AMERICAN POWER CONVERSION

DESCRIPTION	PRODUCT	APCC PART #	SHEET
SB207 CIRCUIT BOARD SCHEMATIC	MINI 250/400 BACK-UPS	OS-207	1 OF 3
DATE	BY	SCALE	DWG
3/15/91	ESM		640-0207D
			REV
			10

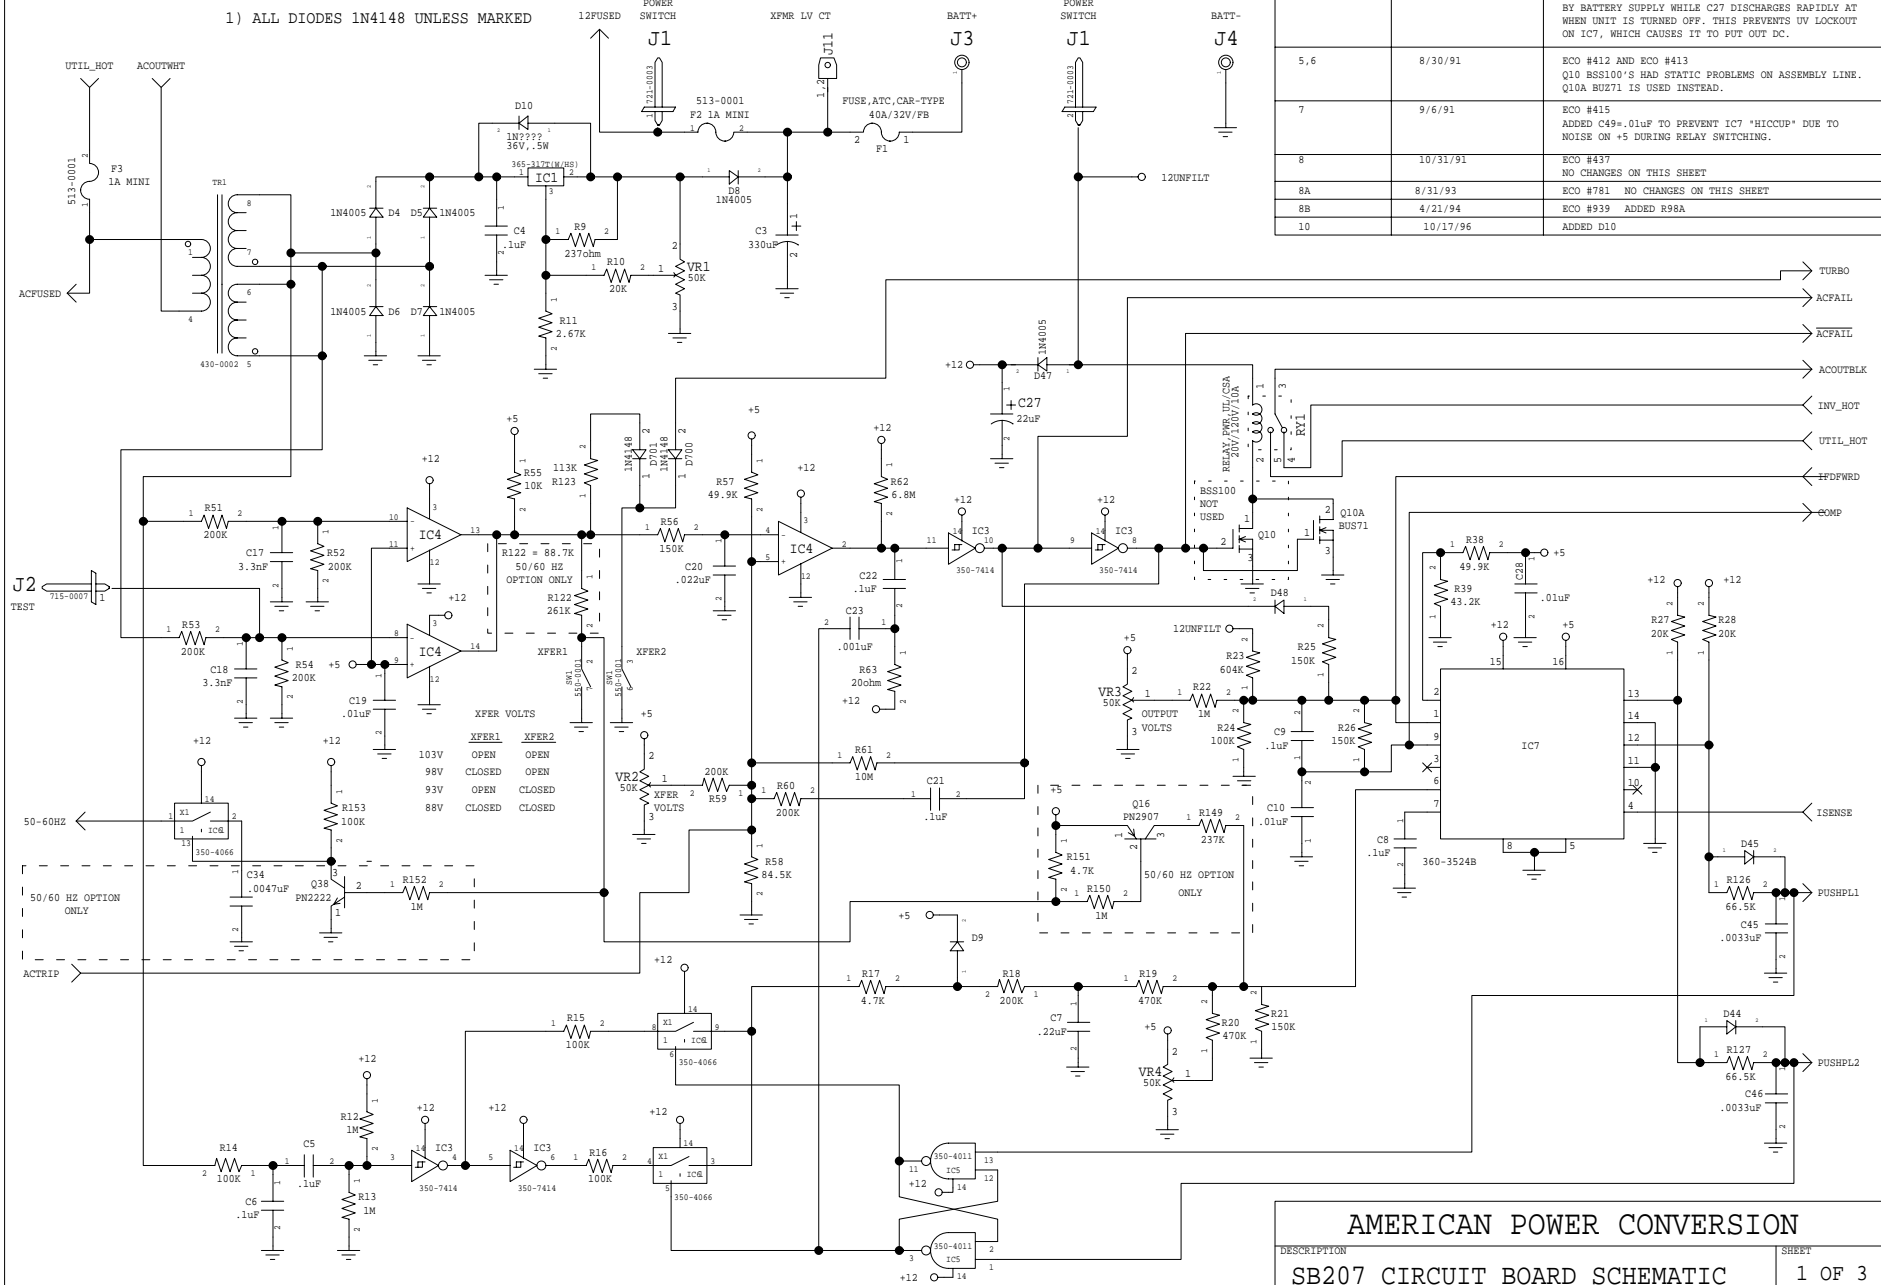
REV #	DATE	REVISION
4	7/17/91	ECO #391 AND ECO #394 REPLACED R75 WITH D47 50 +12 IS NOT DRAGGED DOWN BY BATTERY SUPPLY WHILE C27 DISCHARGES RAPIDLY AT WHEN UNIT IS TURNED OFF. THIS PREVENTS UV LOCKOUT ON IC7, WHICH CAUSES IT TO PUT OUT DC.
5,6	8/30/91	ECO #412 AND ECO #413 Q10 BSS100'S HAD STATIC PROBLEMS ON ASSEMBLY LINE. Q10A BUZ71 IS USED INSTEAD.
7	9/6/91	ECO #415 ADDED C49=.01uF TO PREVENT IC7 'HICCUP' DUE TO NOISE ON +5 DURING RELAY SWITCHING.
8	10/31/91	ECO #437 NO CHANGES ON THIS SHEET
8A	8/31/93	ECO #781 NO CHANGES ON THIS SHEET
8B	4/21/94	ECO #939 ADDED R98A
10	10/17/96	ADDED D10
